# ADDENDUM #03

DATE: August 30, 2022  
 PROJECT: Sininger Hall – School of Business (RFP 23-002)  
 FROM: Baker Architecture + Design  
 TO: All Prospective Offerors

## Addenda Summary:

**G-002**  
 SHEET \_OF\_

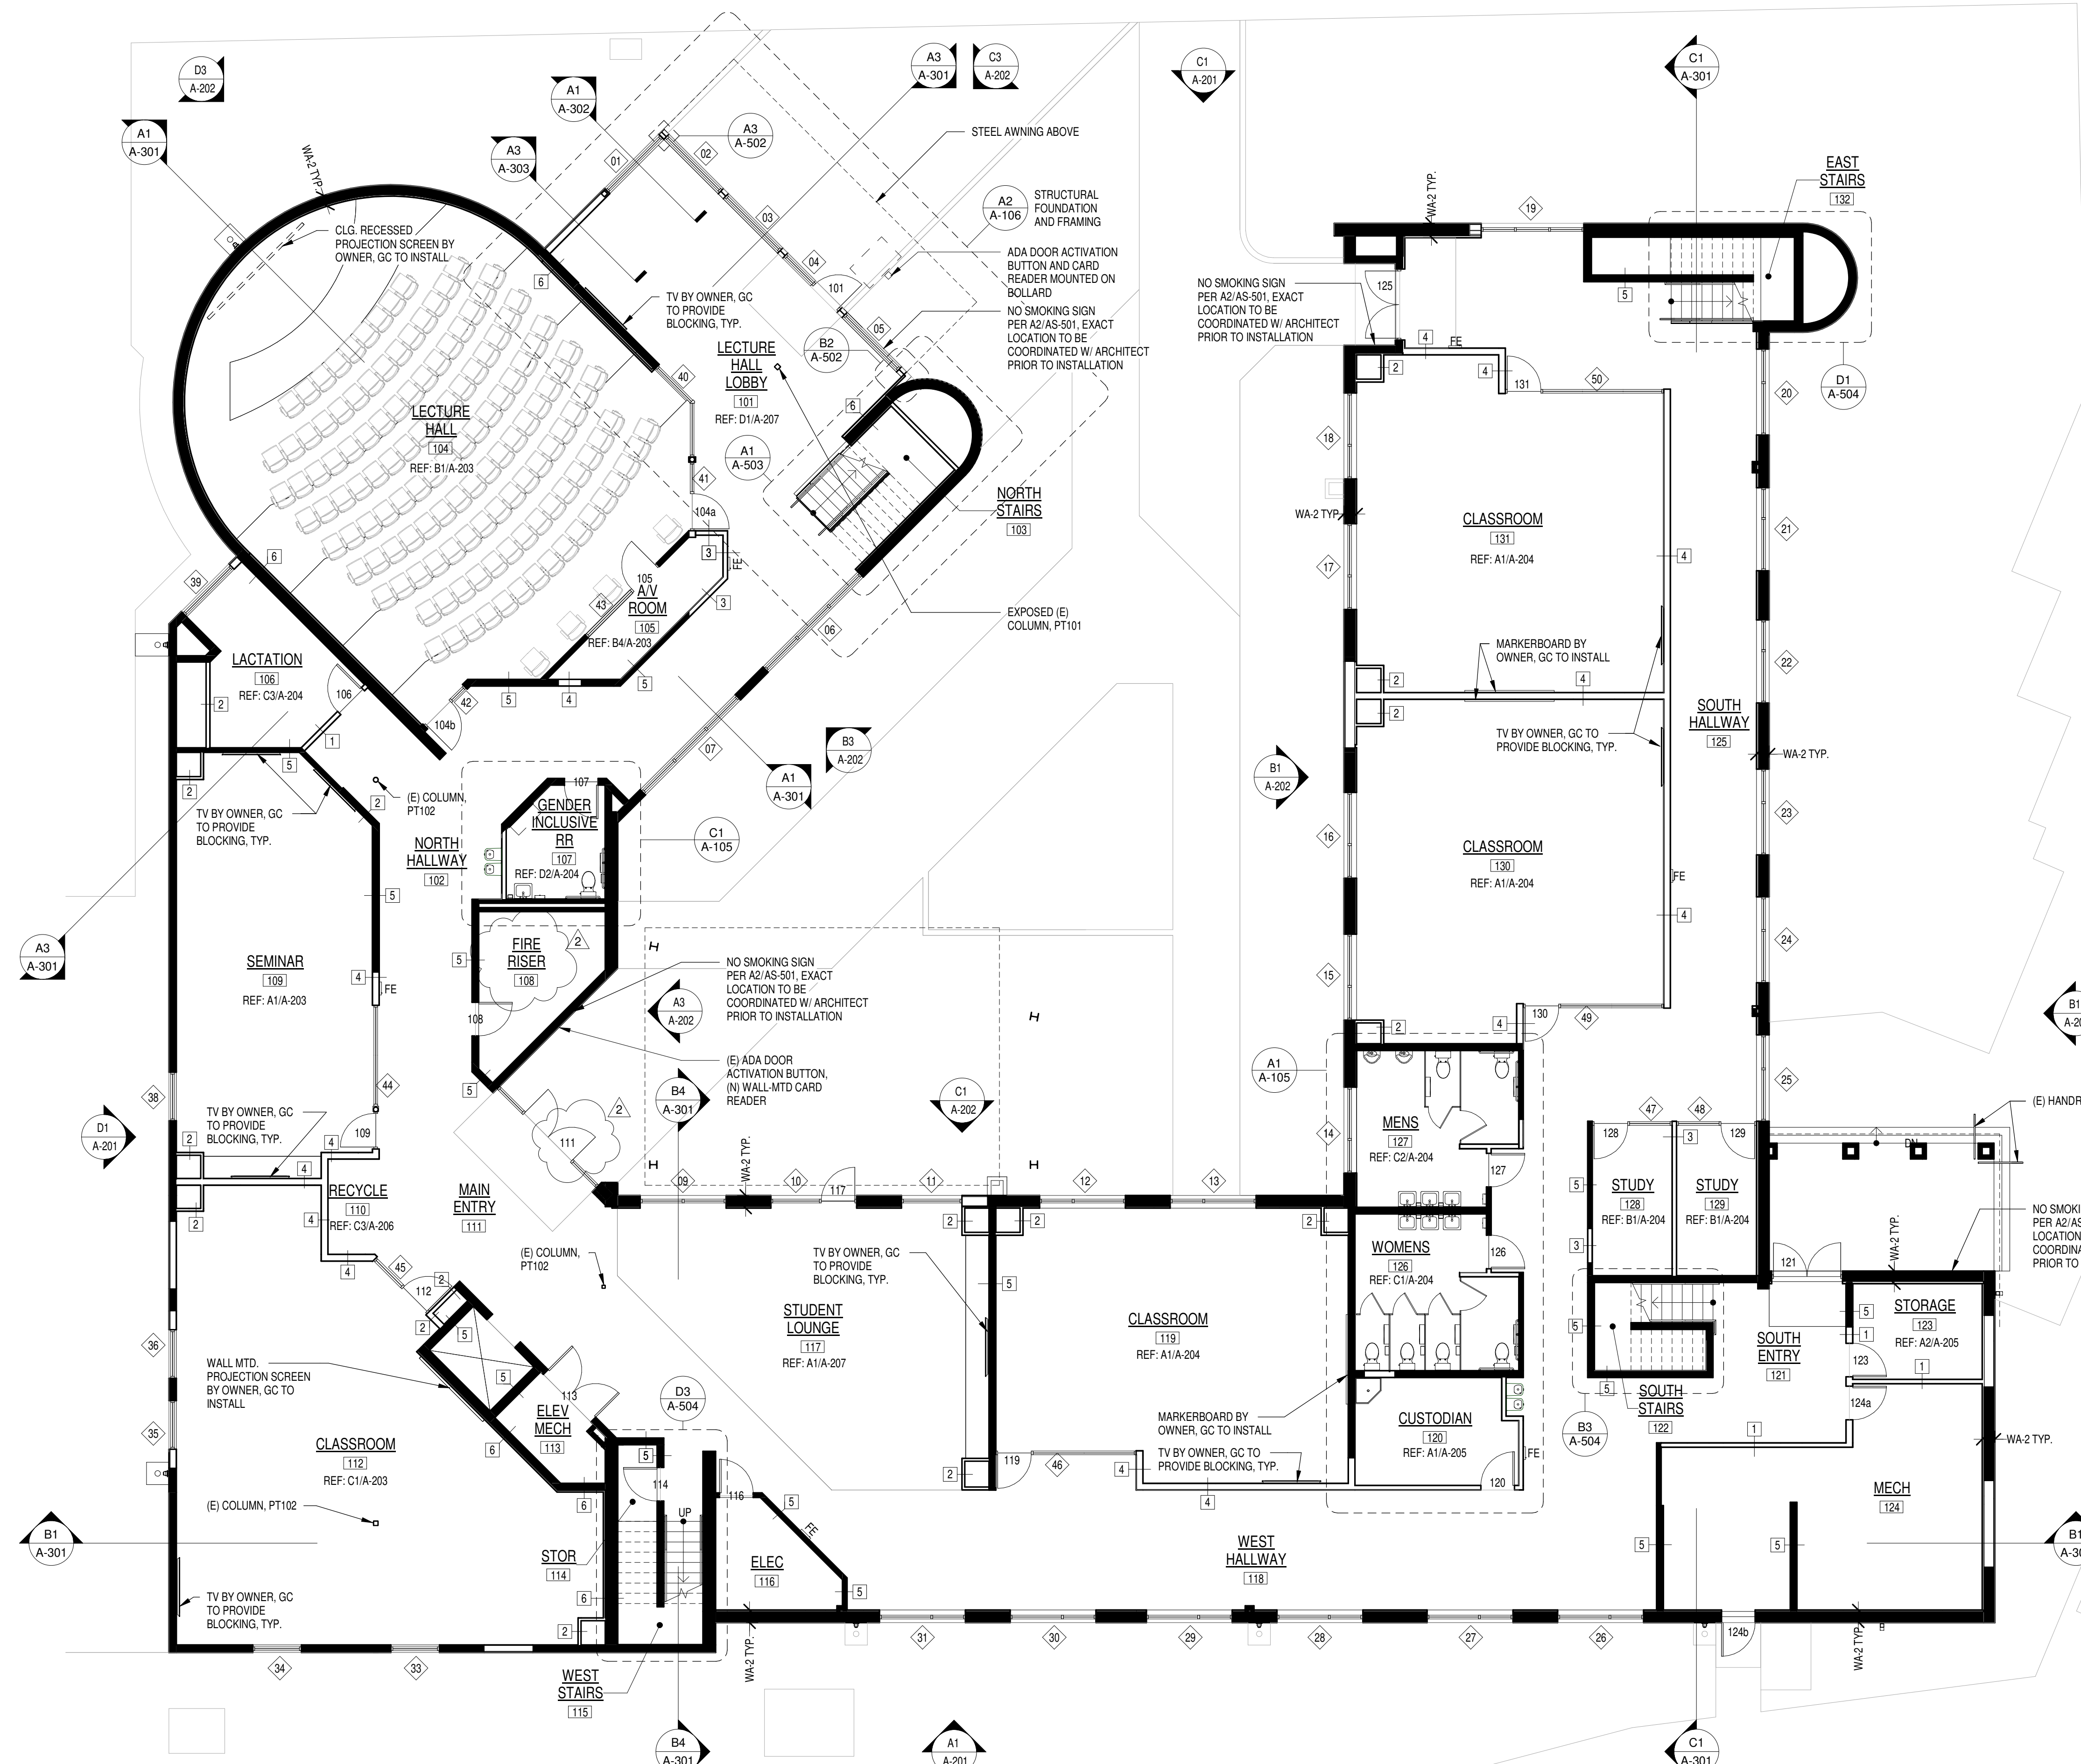
Sheet G-002 – General Information - Added fire suppression notes and modified sheet index

**A-101**  
SHEET \_ OF \_

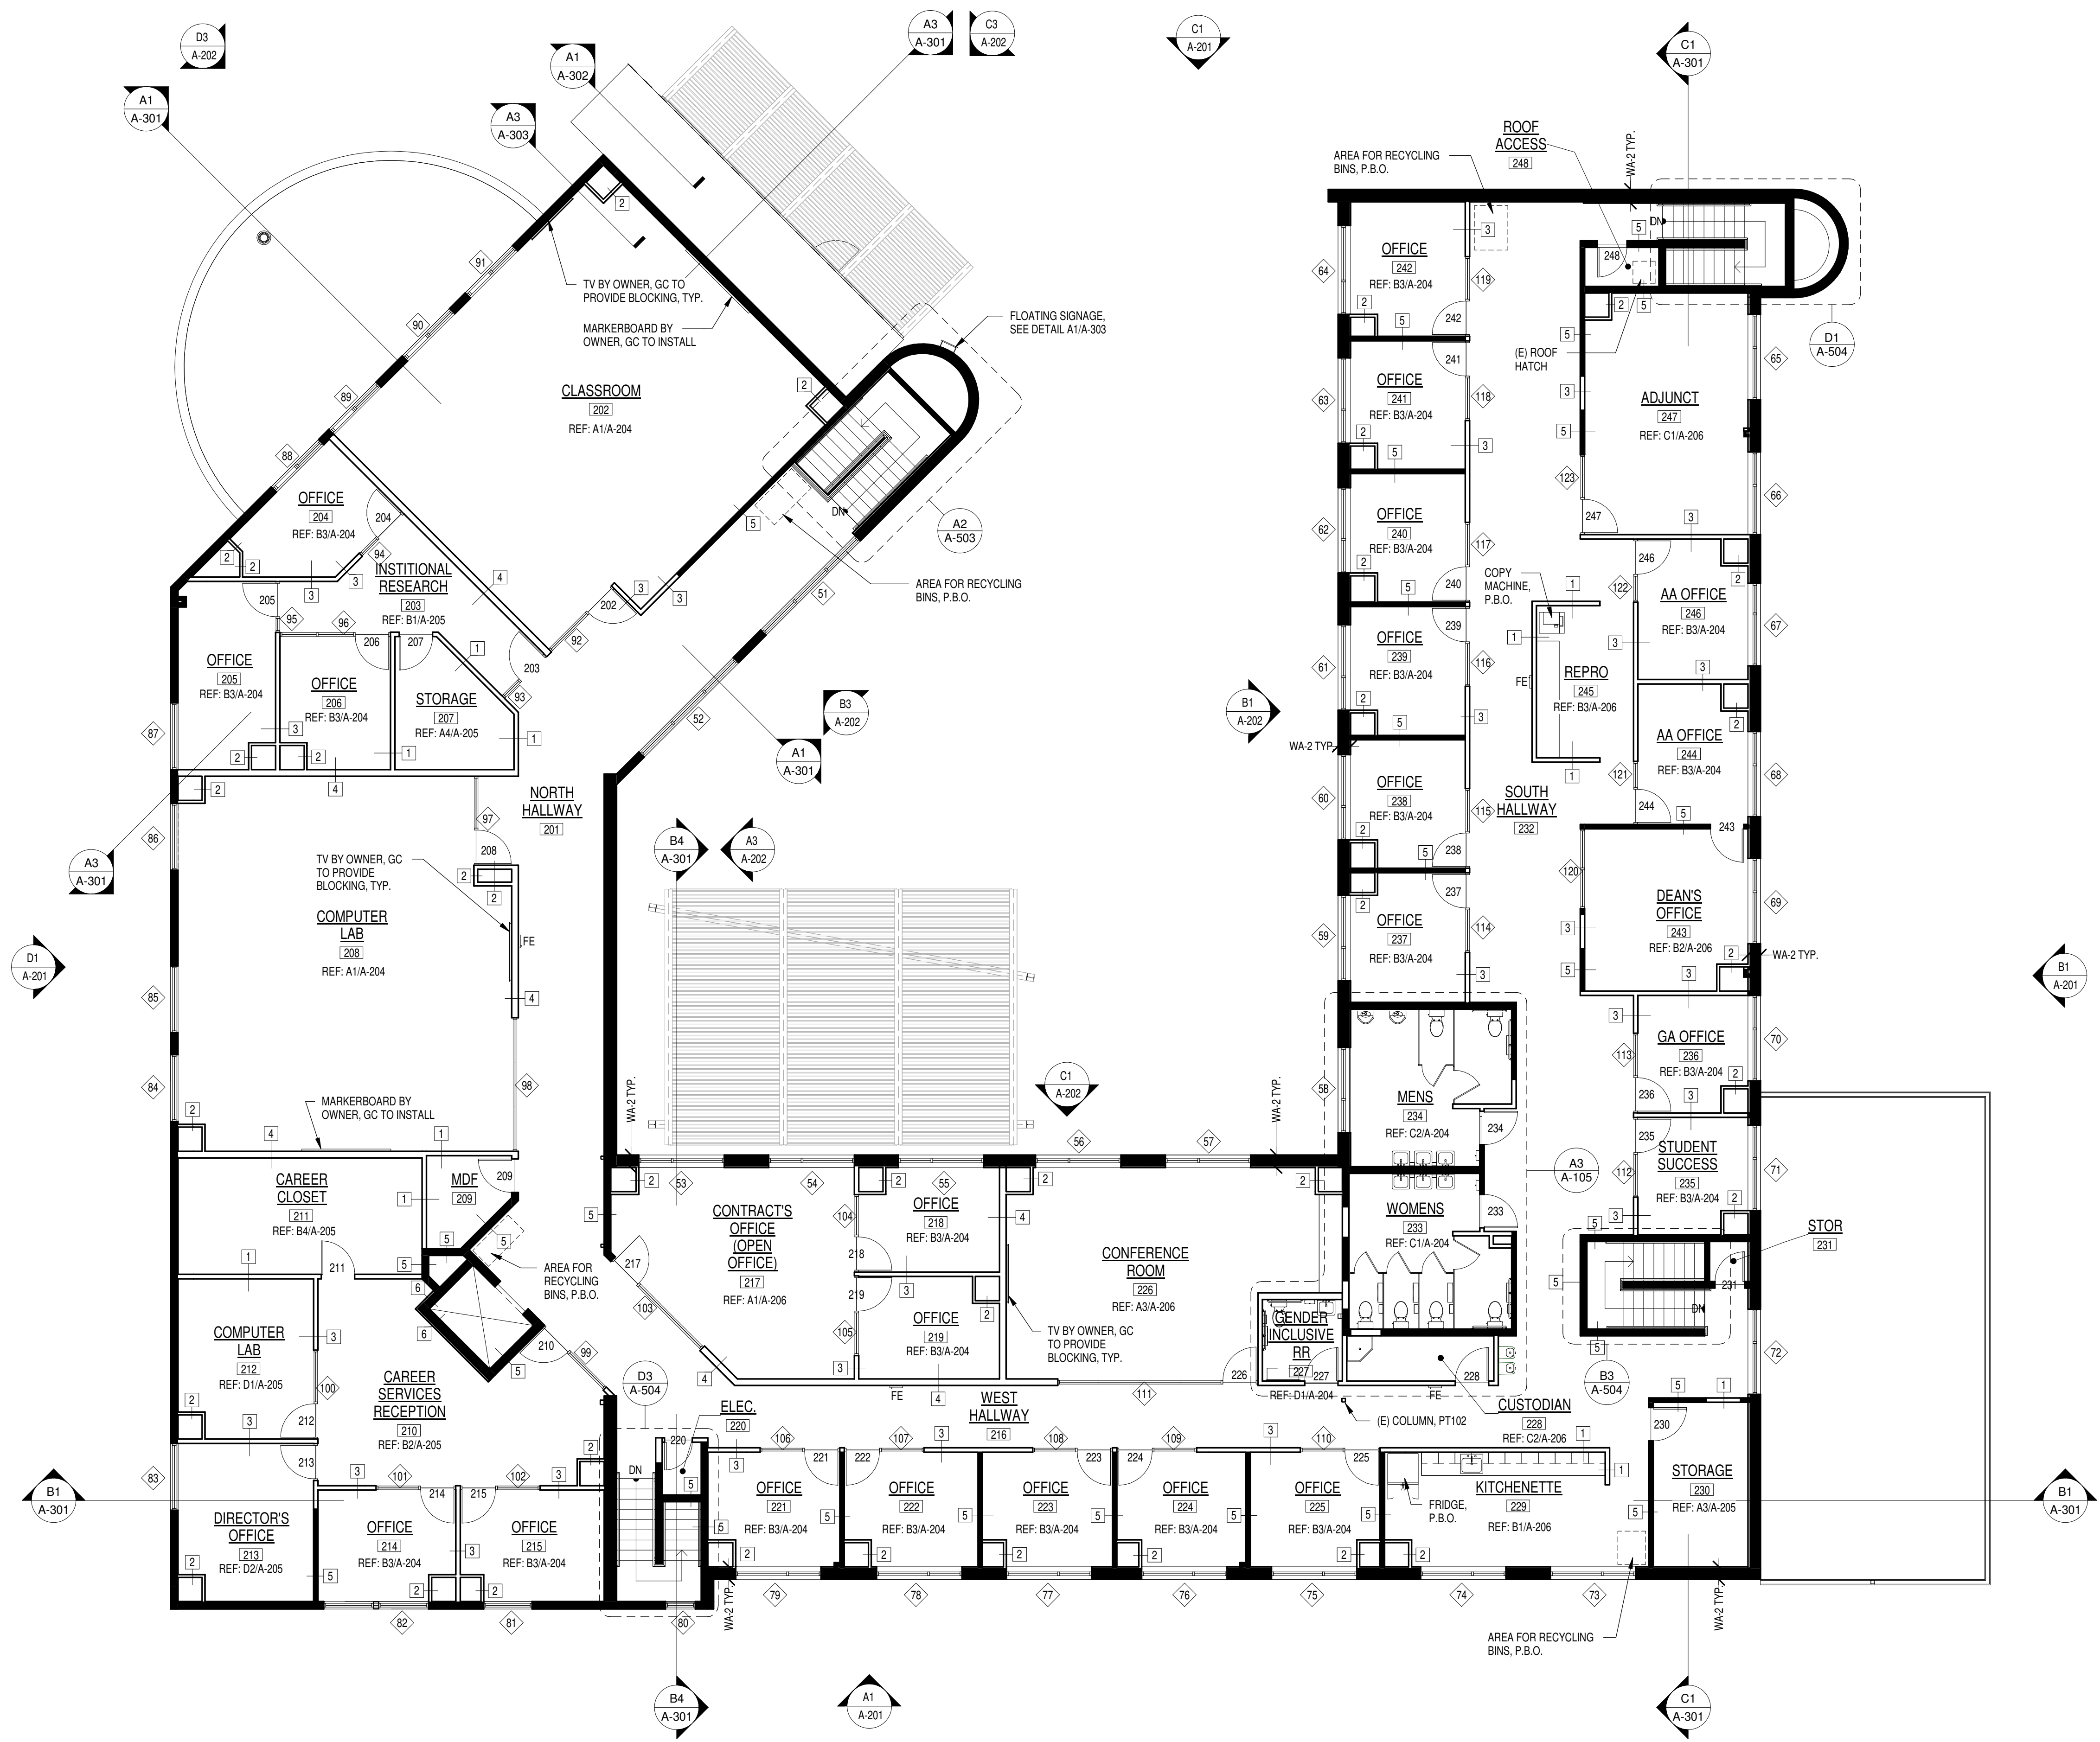
Sheet A-101 – First Floor plan – Furniture layout removed

1. PROVIDE BLOCKING IN WALL FOR WALL MOUNTED TVS AND MONITORS. STUCCO BY OTHERS, GC TO REPAIR ANY DAMAGE IN EXTERIOR WALLS, INFILL, PREP ANY NEW WALLS, AND OTHERWISE COMPLETE WORK REQUIRED FOR STUCCO AND STUCCO RESURFACING. GC TO COORDINATE WITH OWNER AND STUCCO CONTRACTOR FOR COMPLETE REQUIREMENTS AND TIMING OF STUCCO WORK.
2. INSTALL CONTINUOUS INSULATION IN FURROUTS ACCORDING TO WA-2 WHERE NOTED ON FLOOR PLANS.
3. NON-FIXED FURNITURE NOT IN GC SCOPE. REMOVED PER ADDENDUM 3

**A-102**  
SHEET \_ OF \_

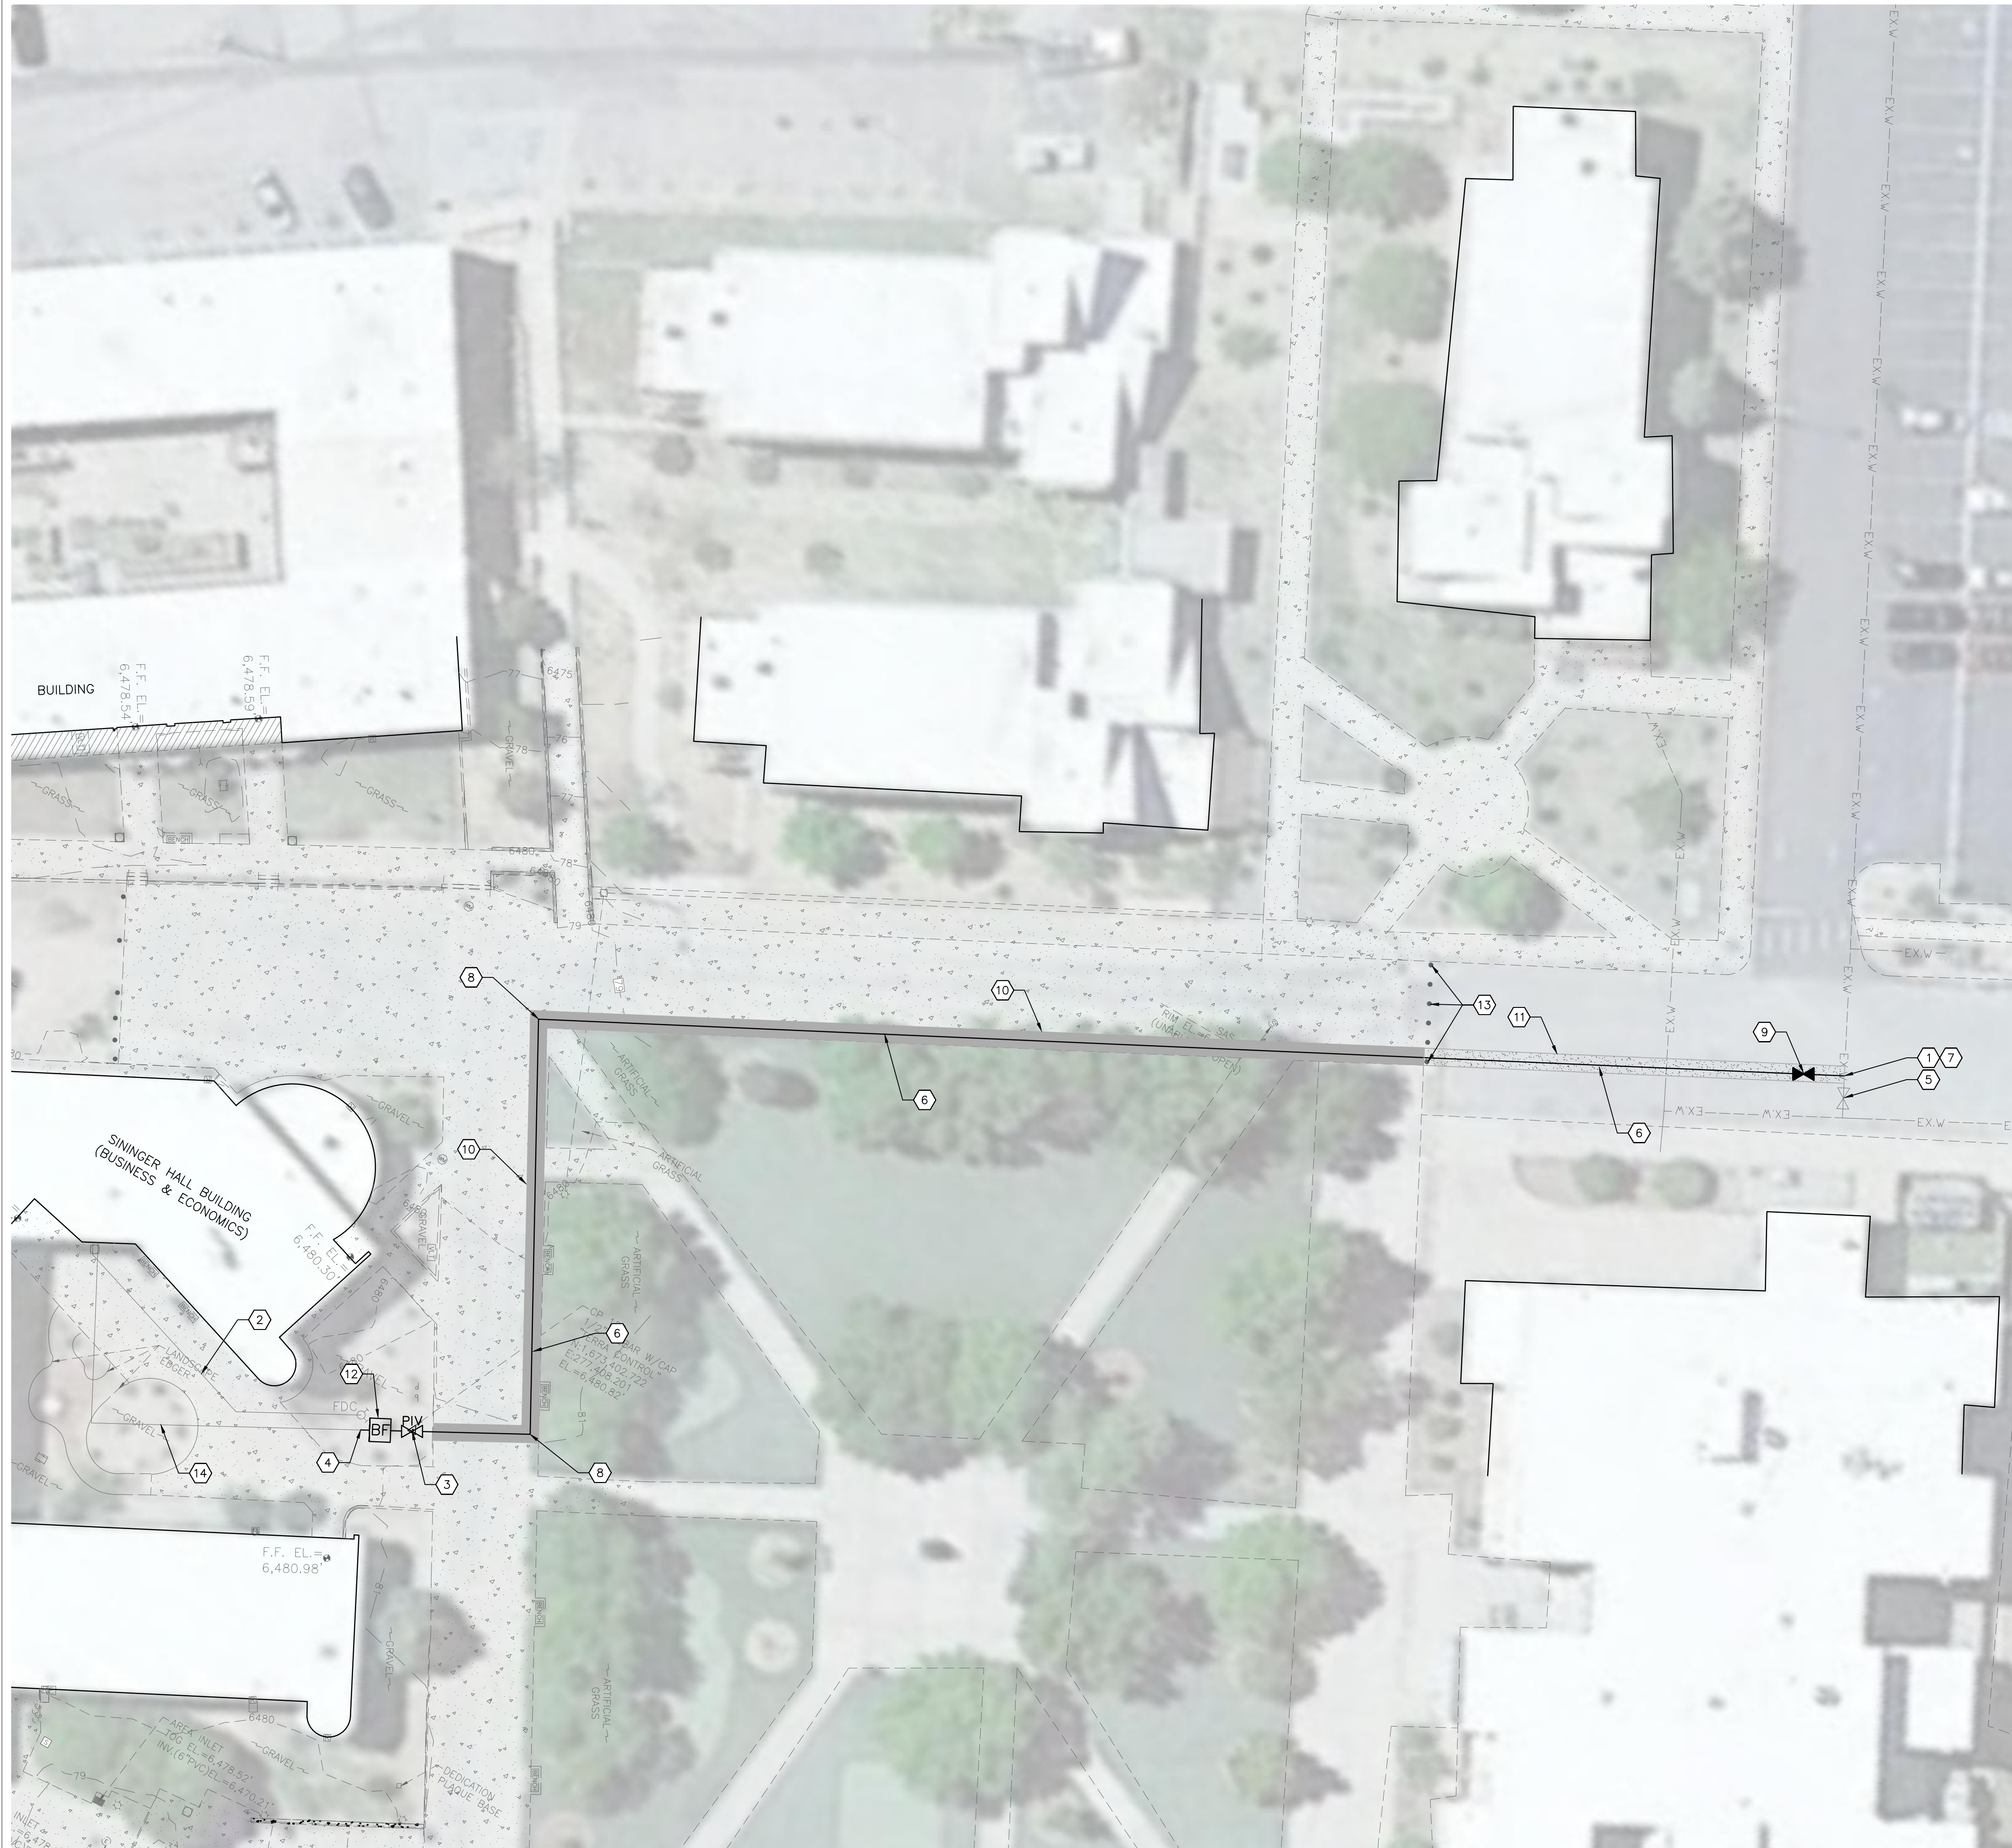
Sheet A-102 – Second Floor plan – Furniture layout removed
